Serial No. 10/729,289

Amendments to the Drawings:

Ser.No. 10/729,289
Amdt. dated 1/17/05
Reply to Off. Action of 12-2-04
Annotated Sheet Showing Changes

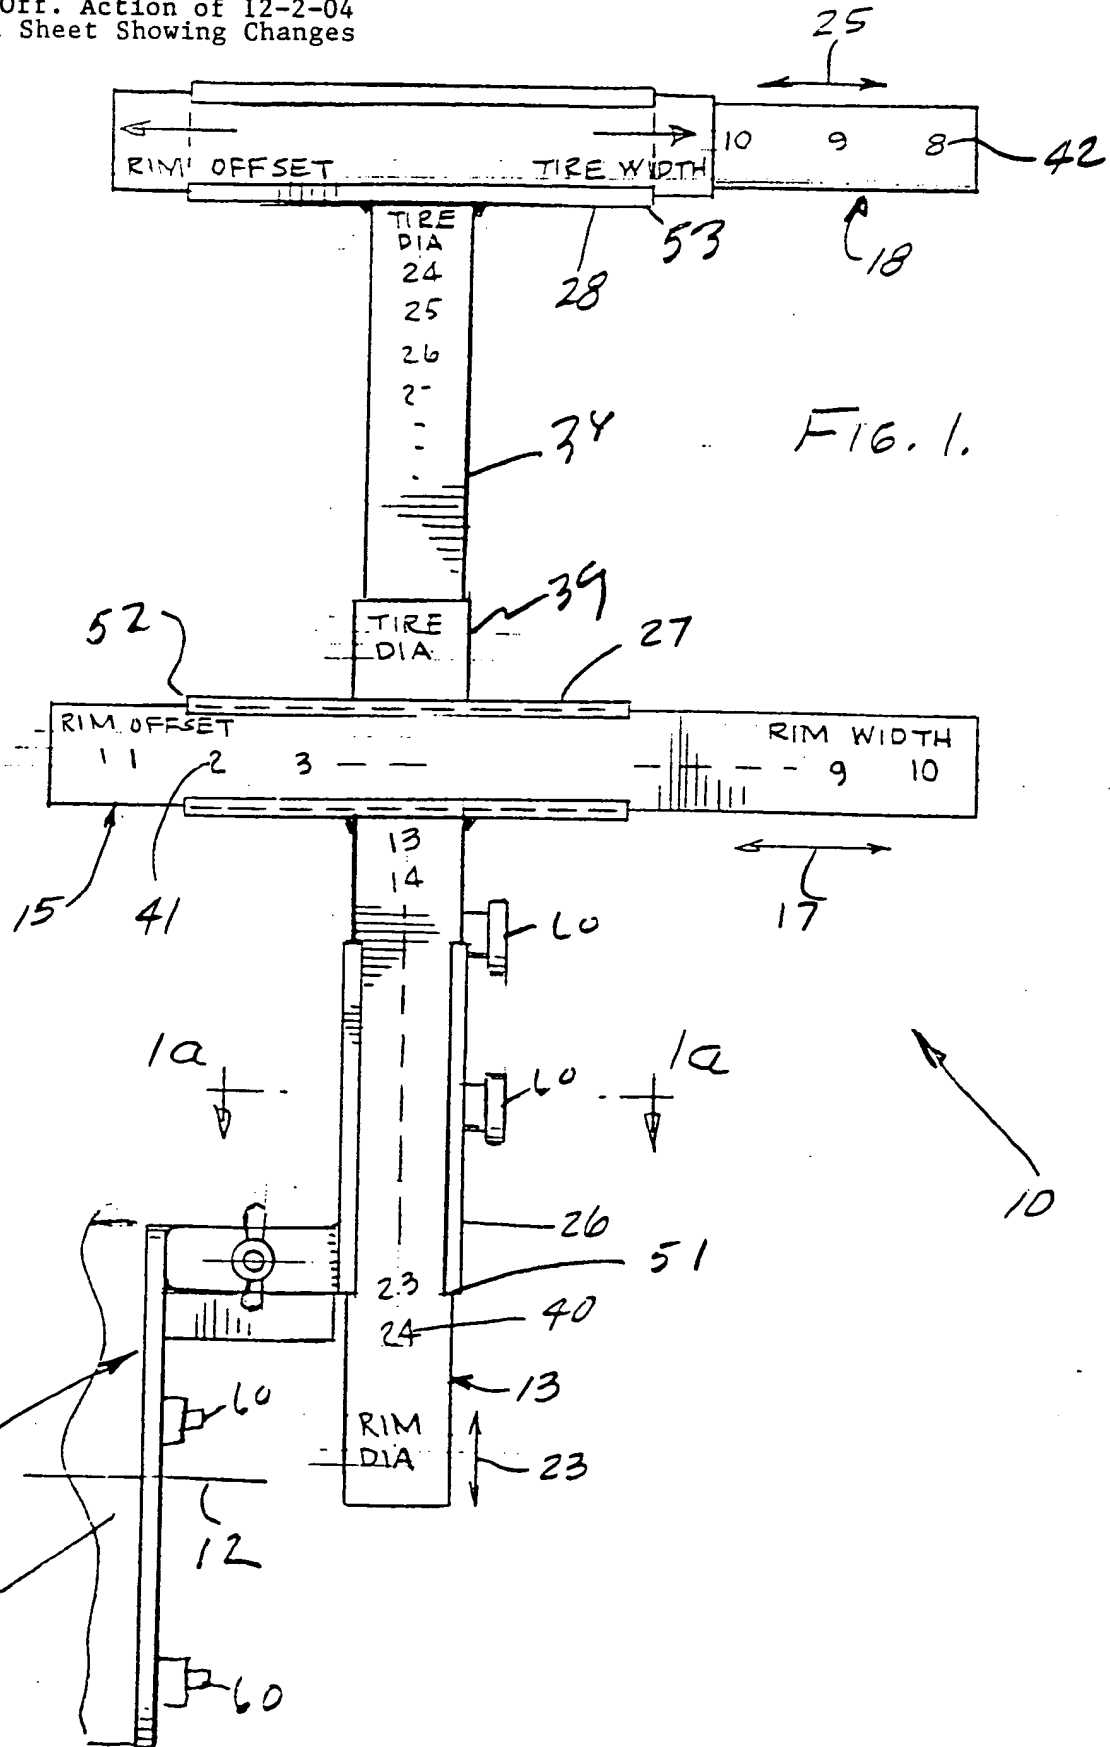
In Fig. 1, the numeral applied to the ''edge'' is now 151 instead of 51.

FIG. 1a.

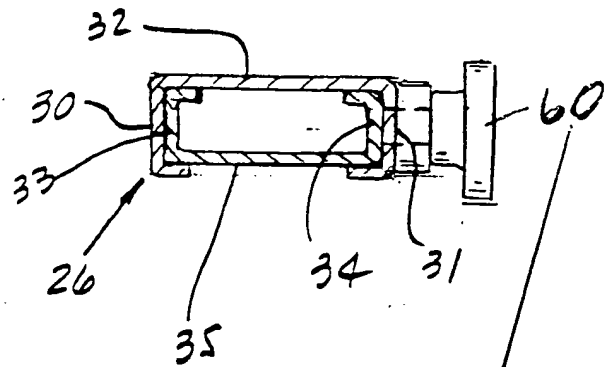
In Fig. 1a, the numeral applied to the ''set screw'' is now 160, instead of 60.

Changed to 160
